POWER DISTRIBUTION LIMITS

## ATTACHMENT 2

### SAFETY EVALUATION

The proposed change to the St. Lucie Unit 2 Technical Specifications is to discontinue the use of Nuclear Flux Peaking Augmentation Factors. Augmentation factors are used at present in establishing setpoints for the peak linear heat generation rate alarm. The changes, which are detailed in Attachment 1, modify part 4.2.1.4 of the Linear Heat Rate Technical Specification and the associated Technical Specification Bases. Figure 4.2.1, which specifies the value of the augmentation factor versus height in the core, is also presented in Attachment 1 and is proposed for deletion by this Technical Specification change.

Figure 4.2-1  
Augmentation factors vs distance from bottom of core

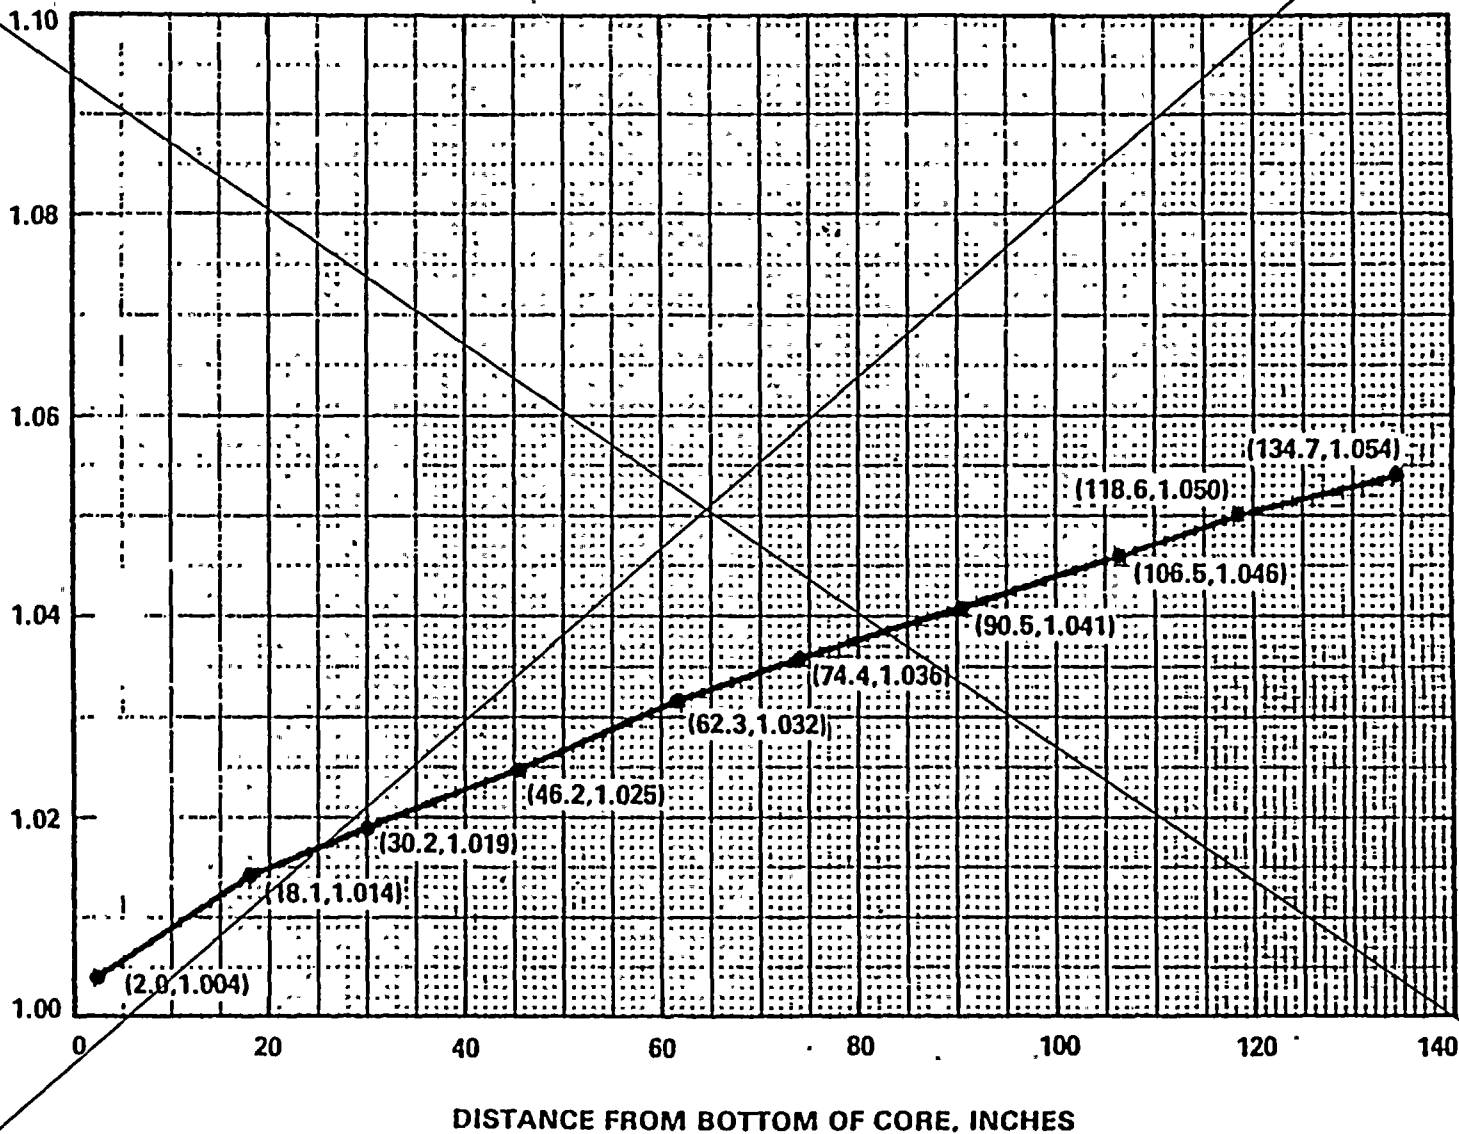
~~1. Flux peaking augmentation factors as shown in Figure 4.2-1,~~

Delete

The purpose for which the Nuclear Flux Peaking Augmentation Factor was originally developed was to provide margin for increased flux peaks which could result from the formation of interpellet gaps in the fuel pellet column and the subsequent local creepdown of the fuel cladding. The augmentation factor is defined as the ratio of the local flux with increased peaks due to interpellet gaps to the local flux in the absence of interpellet gaps. Analysis of fuel performance data such as that in Reference 1 is the basis for determining appropriate sizes and spatial distributions of the gaps used in the calculation of these fluxes.

The proposed change is based on the performance of fuel rods of modern design as compared to the performance of fuel rods of older design for which the flux peaking augmentation factors were originally developed.

Combustion Engineering (CE) has evaluated the factors that cause the formation of gaps and cladding collapse and has concluded that, for fuel designed by CE, significant gaps and cladding collapse will not occur. CE examined fuel supplied to several utilities to verify these conclusions. Because of these results, no flux peaking augmentation factors are required for fuel designed by CE. The justification for this position is presented in Reference 1. No new data has been developed which would require changes to the conclusions presented in Reference 1.

The safety analyses for St. Lucie Unit 2 have been performed in a manner to support the elimination of the augmentation factor. The calculations were either run without the augmentation factors or, if the augmentation factors were used, they were included in a way that would enhance the conservatism of analytical results. The removal of the augmentation criteria will not cause the results of any analysis to exceed design acceptance criteria.
